August 30, 2007

In Reply Refer To: HSSD/CC-100

In your letter of May 16, 2007, you requested the Federal Highway Administration's (FHWA) acceptance of a 31-inch (787 mm) high Slotted Rail Terminal (SRT-31) as a National Cooperative Highway Research Program (NCHRP) Report 350 Test Level 3 (TL-3) system. To support this request, you provided the Texas Transportation Institute (TTI) reports dated May 2007, entitled "NCHRP Report 350 Test 3-30 of the SRT-31" and "NCHRP Report 350 Test 3-35 of the SRT-31". You also provided earlier completed TTI reports on crash testing of a new terminal for cable/wire rope guardrail and on testing of T-31 W-beam guardrail, test videos, and electronic copies of the drawings.

The Texas A&M University System					
Revisions			TEXAS TRANSPORTATION INSTITUTE COLLEGE STATION, TEXAS 77843		
No.	Date	By	Project No.	Date	Drawn By
1.			220541-5	3/07	AJR
2.					
3.					
4.					
5.					
6.					
SYSTEM					Sheet No. 1 of 12

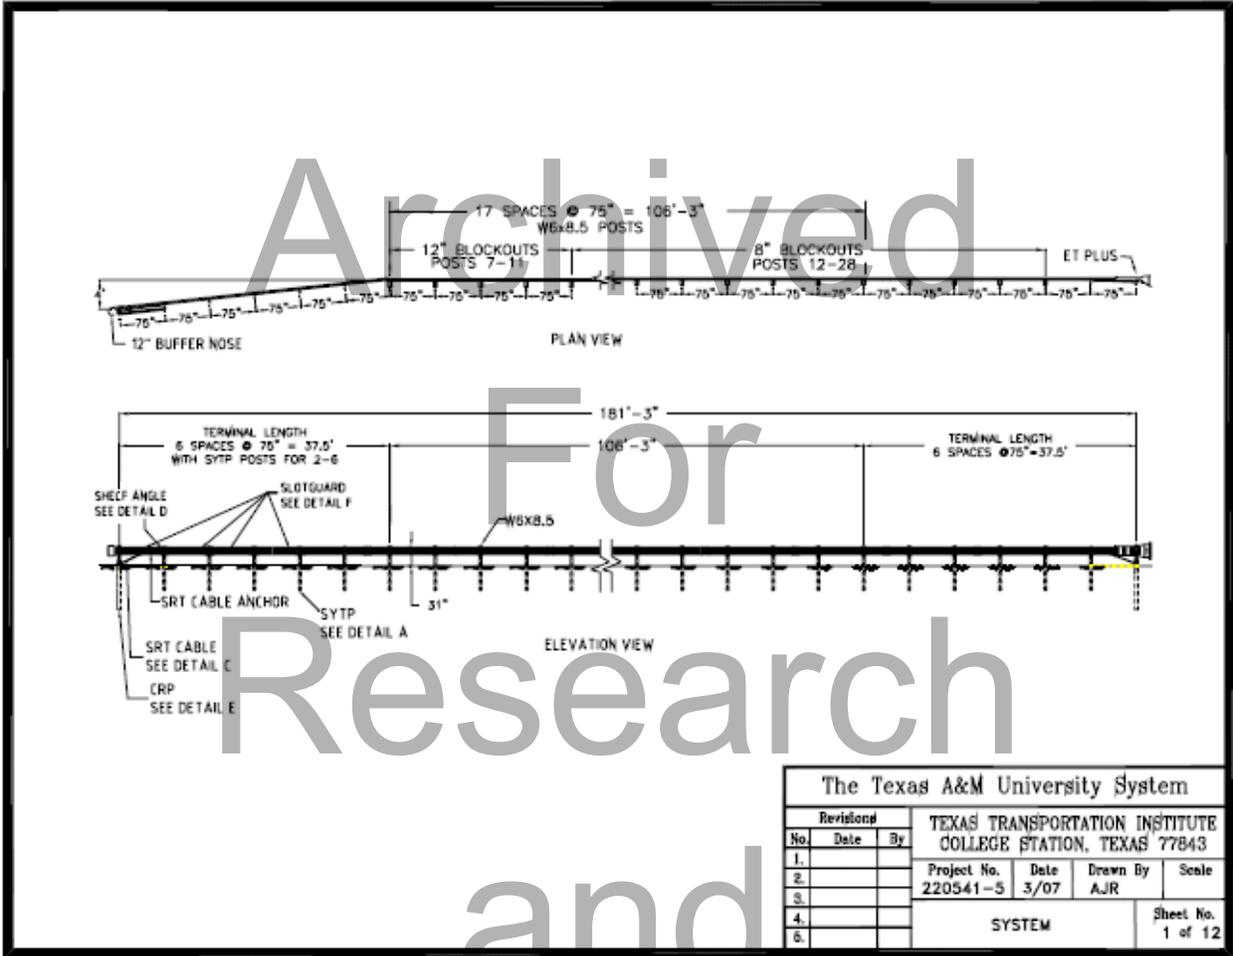
The SRT-31 was developed to be used for terminating 31-inch (787 mm) high strong post W-Beam guardrail systems including 31-inch (787 mm) high Midwest Guardrail System (MGS) with blockouts and 31-inch (787 mm) high T-31 W-beam Guardrail System without blockouts. The design of SRT-31 is based on the previously accepted Slotted Rail Terminals (FHWA acceptance letter CC-72 of December 18, 2000) with the following changes:

1. It is an all-steel terminal.
2. The guardrail is raised to 31 inches (787 mm) throughout the terminal length.
3. No blockouts are used between rail and post at post locations 1 through 6.
4. Upper part of Cable Release Post (CRP) is modified to accommodate 31-inch (787 mm) high guardrail at post 1.
5. Two 12.5 ft (3.8 m) slotted W-beam panels are used between posts 1 and 5, as is currently used in the 27-inch (686 mm) high terminal.

6. Special 9.375 ft (2.86 m) long W-beam panel is used beginning at post 5. This creates mid-span splices between posts 6 and 7, and beyond. If SRT-31 is used with 31-inch (787 mm) systems where W-beam splices are located at posts, a standard 150-inch (3810 mm) long panel is placed between posts 5 and 7.
7. Steel yielding terminal posts (SYTP) are used at post positions 2 through 6.
8. W-beam is disconnected at posts 2 through 5.
9. W-beam backup plates are used at post positions 2 and 4.
10. Shelf angle is used at post position 2 to provide rail support for vertical forces that occur during redirection tests.
11. Standard W6 x 8.5 (W150 x 12.6) or W6 x 9 (W150 x 14) line post is used at post position 7.

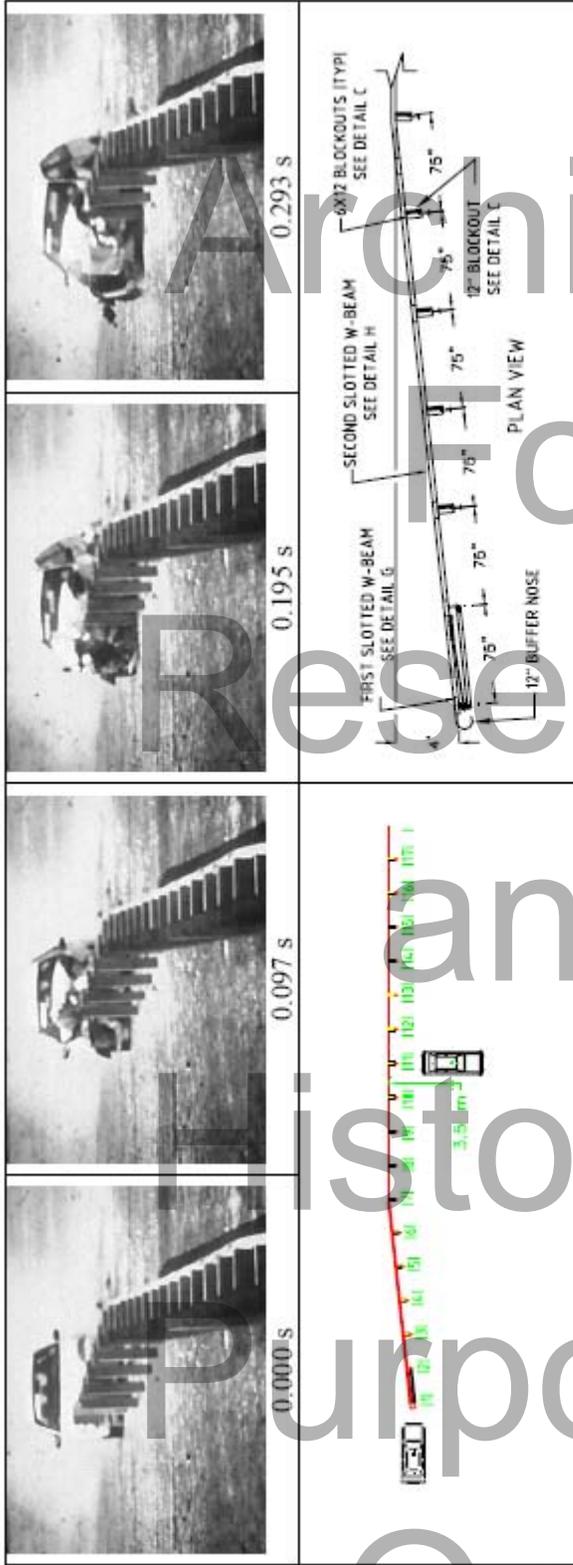
In test 3-30 SRT-31 slowed the 820C vehicle as the vehicle gated behind the terminal in a controlled manner subsequently coming to rest on the back side of the terminal. The vehicle remained upright during and after the collision event. No penetration of the occupant compartment occurred and maximum occupant compartment deformation was 0.7 inch (18 mm) in the driver's side door panel area near hip height. Occupant risk factors were within the preferred limits.

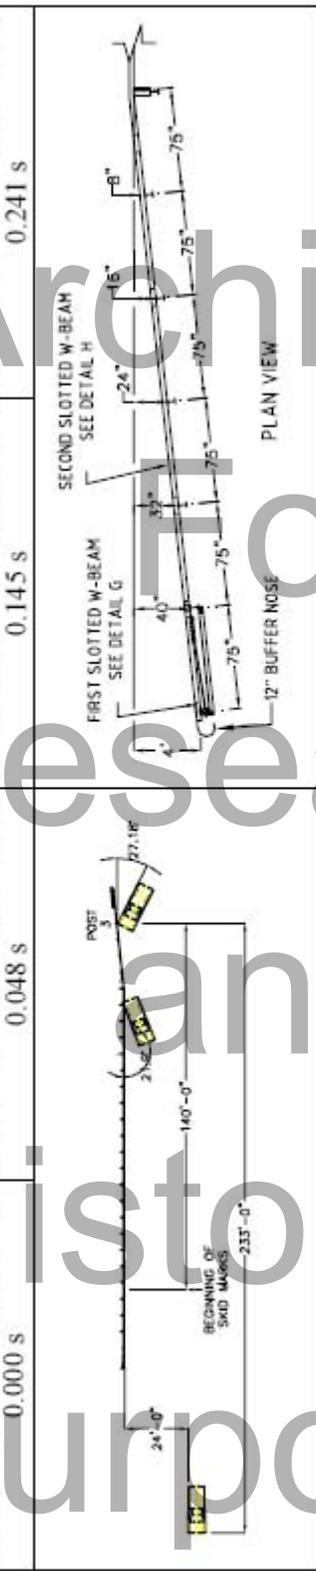
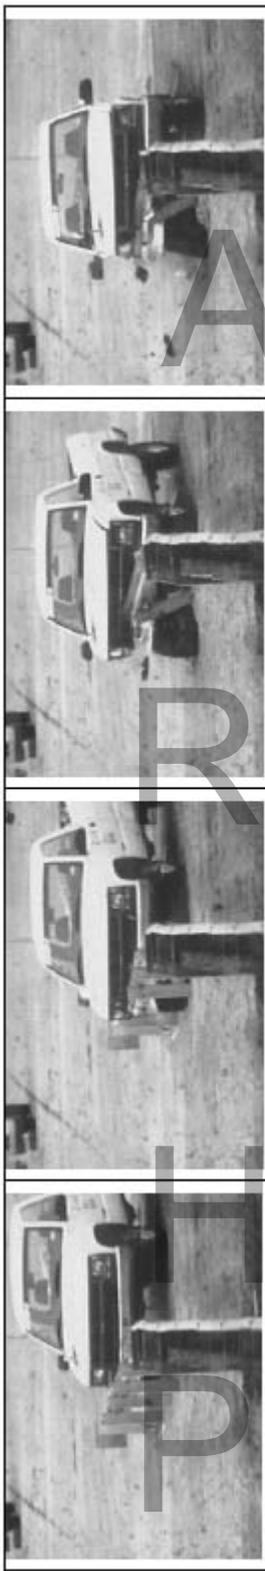
In test 3-35 SRT-31 contained and redirected the pickup truck. The rail element separated from all posts of the system, but the anchor cable maintained attachment keeping the rail adjacent to the posts. No occupant compartment deformation occurred. The pickup truck remained upright

during and after the collision event. No occupant compartment deformation occurred, and occupant risk factors were within the preferred limits. Based on the results of test 3-35, the beginning of length-of-need of the SRT-31 is at post 3, approximately 12.5 ft (3.8 m) from the end.
